SERVICE BULLETIN AMATEUR RADIO

SUBJECT	DATE
SM-230 RTTY CROSS PATTERN ATTENUATION	08/08/90

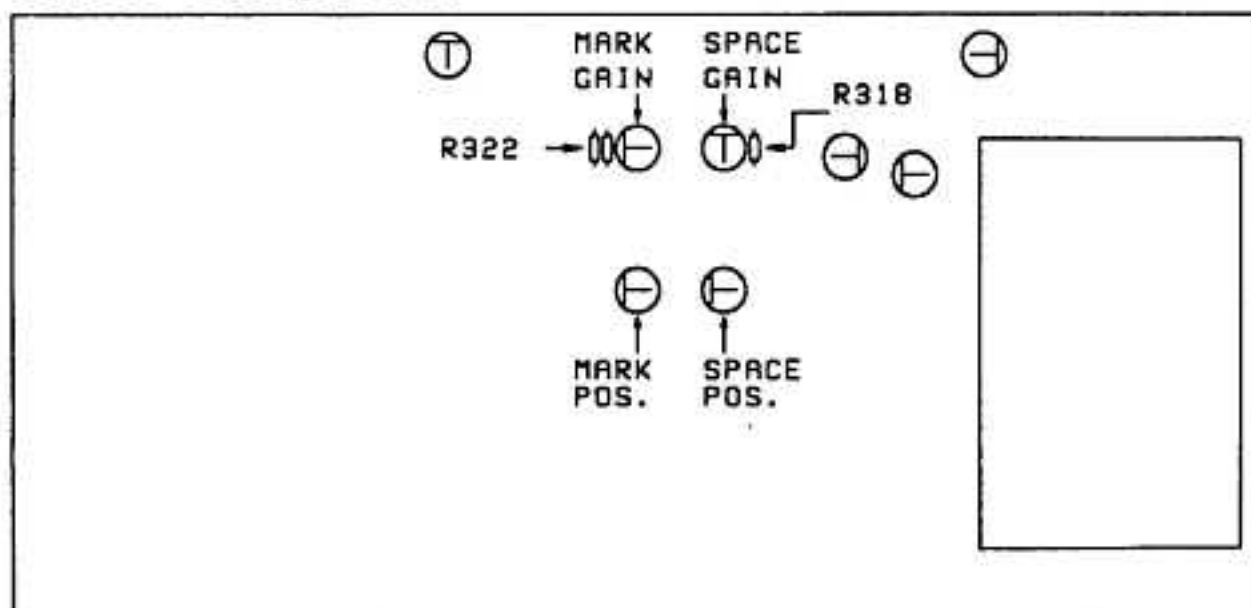
Some users of the SM-230 have reported that the MARK and SPACE gain adjustments do not sufficiently reduce the signals to display them on the CRT. The following modification will correct this condition.

REQUIRED PARTS:

680 OHM 1/8W RESISTOR RD14CB2B681J QTY. 2

1. Disconnect the power cord and control cables.
2. Remove the top cover (6 screws).
3. Locate the Horizontal unit. This board is vertically mounted on the right side of the SM-230.
4. Locate resistors R318 and R322 on the Horizontal unit.
5. Replace R318 and R322 with 680 ohm resistors.
6. Assemble the SM-230.
7. Adjust the MARK and SPACE gain adjustments as necessary to obtain the correct cross pattern.
